BALTIMORE GAS AND ELECTRIC COMPANY

March 5, 1981

Subject: Calvert Cliffs Nuclear Power Plant
Units Nos. 1 & 2, Dockets Nos. 50-317 & 50-318
NRC Requirements for Auxiliary Feedwater System

Proposed Modification To CCNPP AFW Section Piping

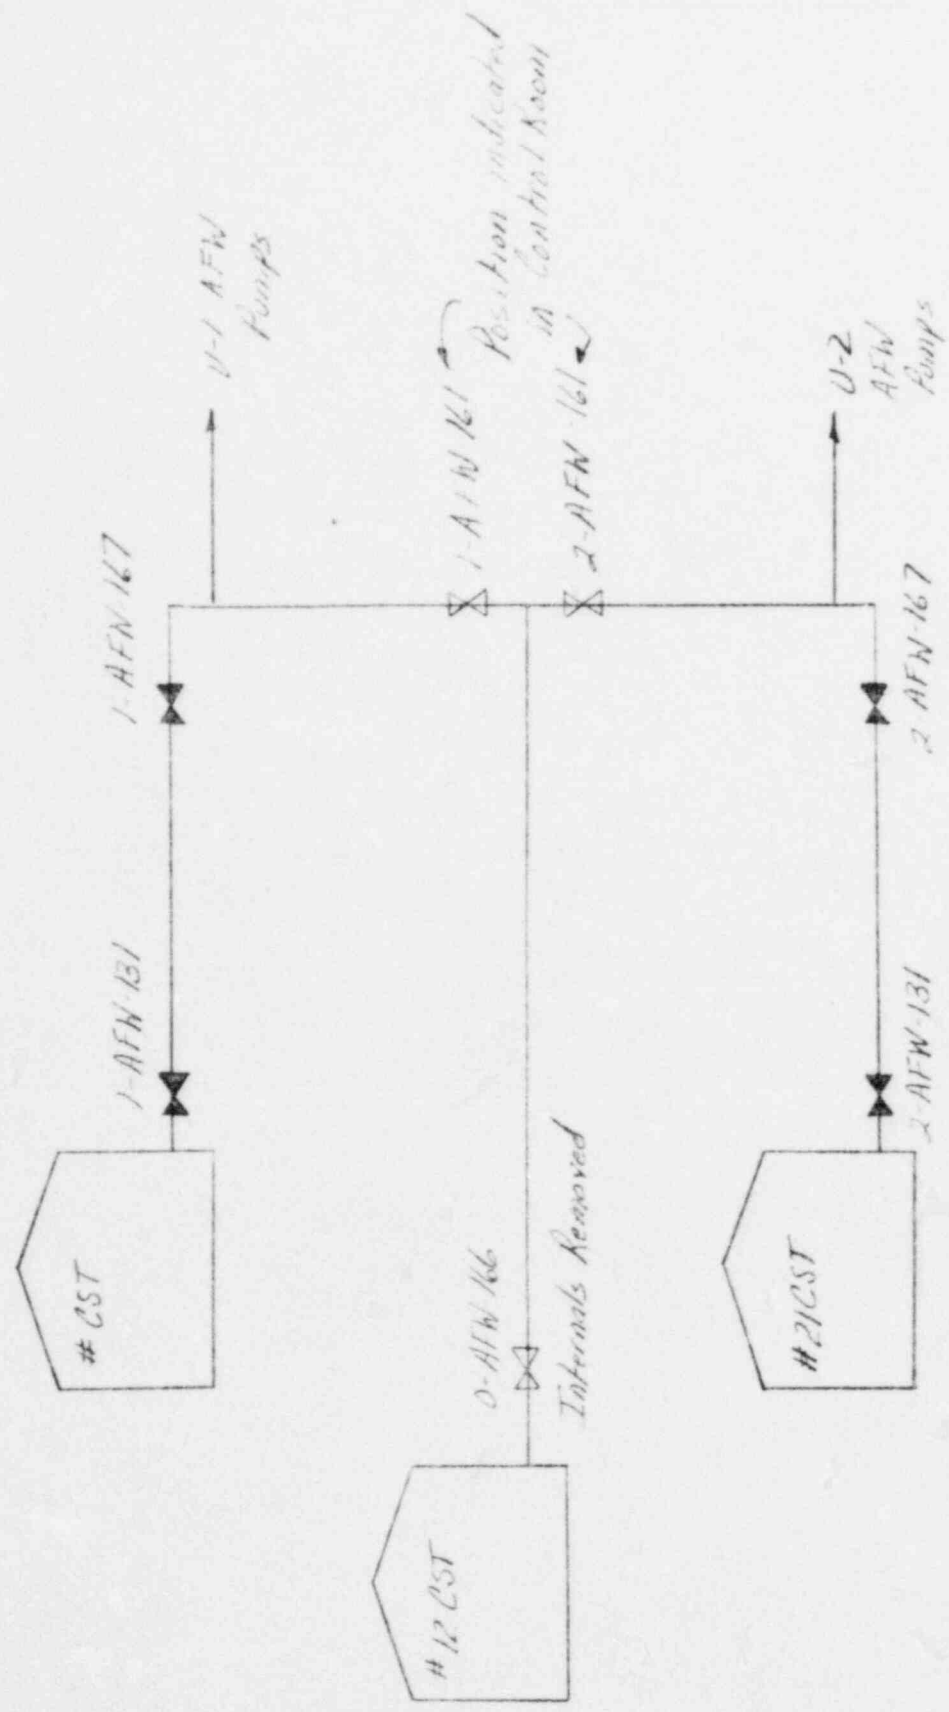
As can be seen from the above numbers, installing the bypasses around 1-AFW-161 and 2-AFW-161 does not significantly improve the availability of the system. It will not even improve reliability by a factor of two.

We estimate the cost of installing these two valves to be \$40,000. This does not include replacement power costs due to the outage being longer because men are diverted to perform this task. In addition to this, it may be necessary, because of tech spec requirements, to shut down both units at the same time for this work. To avoid shutting down the unaffected unit we would have to maintain 150,000 gallons in the alternate condensate storage tank (CST). The alternate CST (No. 11 or No. 21) is the normal source of makeup water for the unit's condensate system and depending on makeup requirements we may not be able to maintain the required 150,000 gallon capacity. Without demonstrating the operability of the alternate CST we would have to shutdown the unit within 16 hours per tech spec 3.7.1.3. It currently costs \$760,000/day/unit for replacement power.

Even based solely on the \$40,000 expenditure to install these valves, we feel that the small increase in availability does not warrant the cost. We propose to modify the suction piping lineup as discussed in reference (c) to that shown on the attached drawing.

We request the NRC review this proposed modification in light of the information provided on costs and reliability. Due to the long lead time associated with ordering equipment we desire a response as soon as possible. Should you have any questions, feel free to contact us.
